# UNITED STATES PATENT AND TRADEMARK OFFICE

10/666,542

<b>Office Action Summary</b>	<b>Application No.</b> 10/666,542	<b>Applicant(s)</b> APEL, THOMAS R.	
	<b>Examiner</b> Michael B. Shingleton	<b>Art Unit</b> 2815

**DETAILED ACTION*****Claim Rejections - 35 USC § 103***

Figure 2 (Taniguchi)

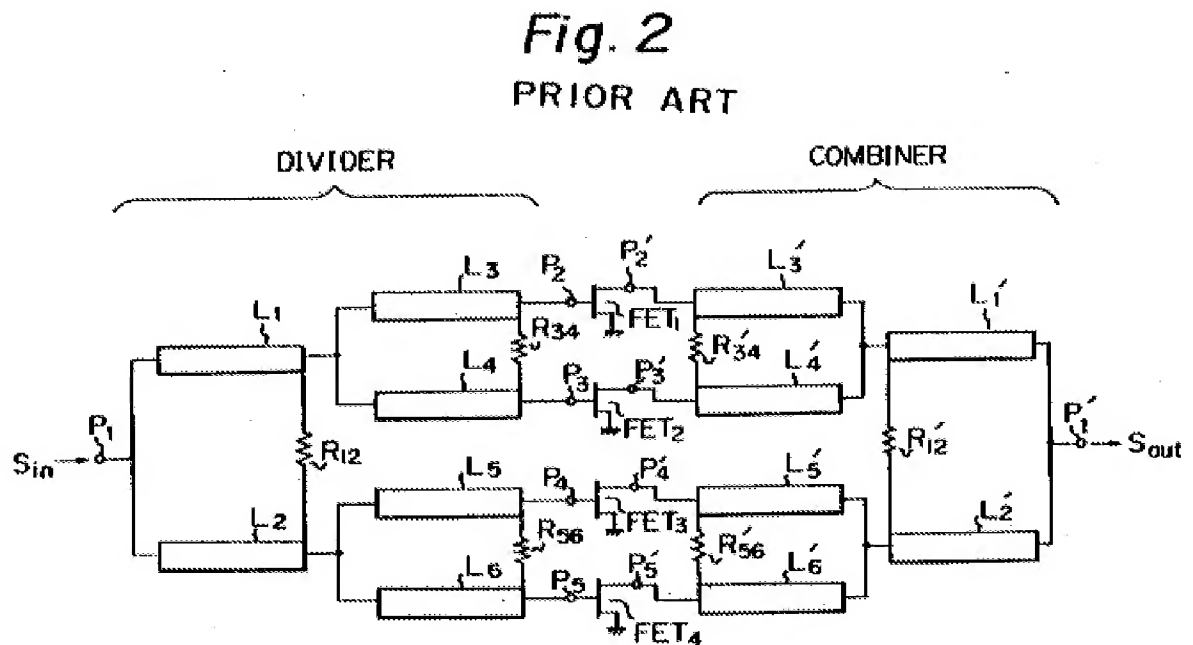
Figure 2 of Taniguchi discloses a power amplifier circuit. Note that the goal of these circuits of Taniguchi is to “obtain a high power high frequency signal” (See column 3, around line 59) and thus these circuits are power amplifier circuits. Taniguchi includes a first amplifier “subsection”  $L_3$  and  $FET_1$

(Herein and throughout referred to just as the first amplifier.) that is configured to receive an input signal that is the unmarked signal at the node that directly connects elements  $L_1$ ,  $L_3$ , and  $L_4$ . Note that the first amplifier receives this signal through element  $L_3$ . This is only giving the broadest reasonable interpretation to the claims consistent with the specification. See MPEP 904.01. The first amplifier clearly provides a “first” output signal. Element  $L_4$  of Taniguchi is a first delay element that introduces a delay to the input signal and applies this to the input of a “second” amplifier “subsection”  $FET_2$  (Herein and throughout referred to just as the second amplifier.). This second amplifier clearly has an output signal and provides a “first” delayed output signal to the node directly connecting elements  $L_3'$ ,  $L_4'$  and  $L_1'$ . The top of page 9, of applicant’s specification clearly sets forth that an impedance inverter can be a quarter wavelength transmission line. Thus all the quarter wavelength lines of Taniguchi are “impedance inverters” as set forth by applicant and is in accordance with applicant’s application. These impedance inverters of Taniguchi are in accordance with applicant’s specification provides the “impedance inversion”. Thus the impedance/delay element  $L_3'$  also introduces a second delay to the first output signal thereby creating a second delayed output signal. The node directly connecting elements  $L_3'$ ,  $L_4'$  and  $L_1'$  and the node directly connecting elements  $L_5'$ ,  $L_6'$  and  $L_2'$  in combination with the node that directly connects elements  $L_1'$  and  $L_2'$  provides the means for combining the first and second delayed output signals that ultimately provides the high frequency amplified output signal  $S_{out}$ . This output signal is provided on the output terminal “ $P_1$ ”. Taniguchi is silent on showing the bias circuit and supply circuit or what applicant calls “level control circuit” in claims like claim 1 for example that biases the first and second amplifiers to operate in the saturation range, i.e. non-linear classes of operation. Applicant should note that while Taniguchi is silent on the bias circuit or “level control circuit”. As is known to those of ordinary skill in the art, Taniguchi inherently must have a bias circuit and power supply circuit because this is a necessary circuit needed so that the amplifier(s) can operate.

The structure indicated above clearly provides for the claimed method of the claims indicated at the beginning of this rejection except for as indicated above Taniguchi is silent on providing a bias control circuit/level control circuit that biases the amplifiers such that non-linear operation is obtained.

Figure 2(Apel)

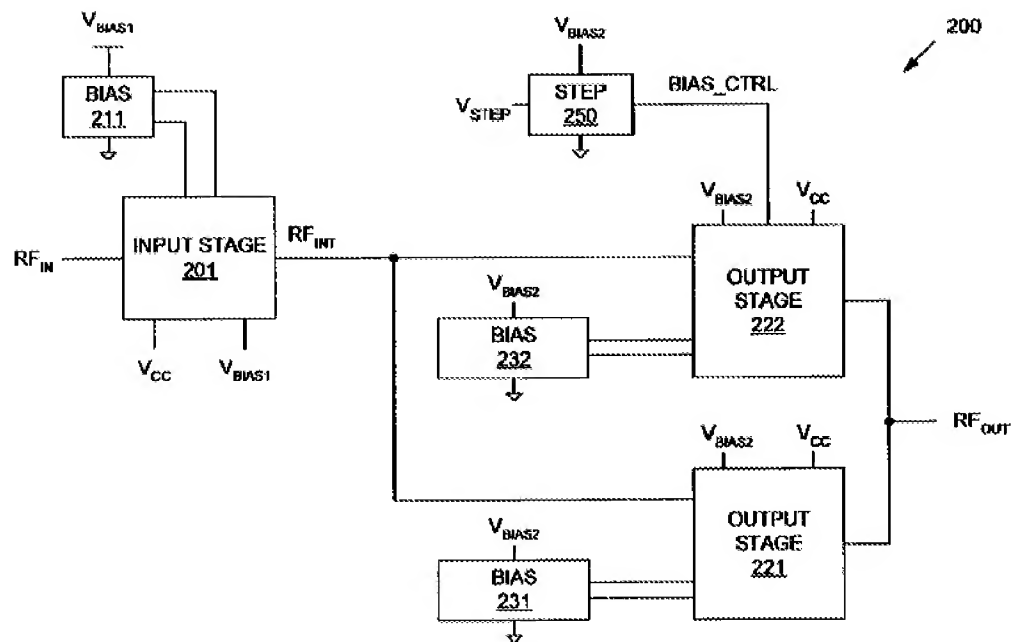
Figure 2 of Apel teaches one way to have a multi-channel amplifier arrangement provide for low power and high power modes. This includes the providing of a “bias control circuit” 231, 232, 250 that enables the first amplifier 221 when the “level control signal”  $V_{STEP}$  is set for a low power mode and which enables the second amplifier 222 when the “level control signal” is set for a high power mode.

Thus it would have been obvious to one of ordinary skill in the art at the time the invention was made to provide the combination of Taniguchi and Holt with a bias control circuitry such as that of Apel so as to enable the first amplifier during a low power mode indicated by a level control signal and enable both the first and second amplifiers when the level control signal indicates a high power mode. Therefore the multi-channel amplifier arrangement can be made to provide more than one power level output mode as taught by Apel.

Note that the selection of the bias points of the bias circuits in the combination of Taniguchi, Holt and Apel results in the level control circuit, i.e. the unshown circuit that provides the level control signal  $V_{STEP}$ , to allow for the level control circuit to cause the first and second amplifiers to operate in the saturation mode when these amplifiers are enabled.
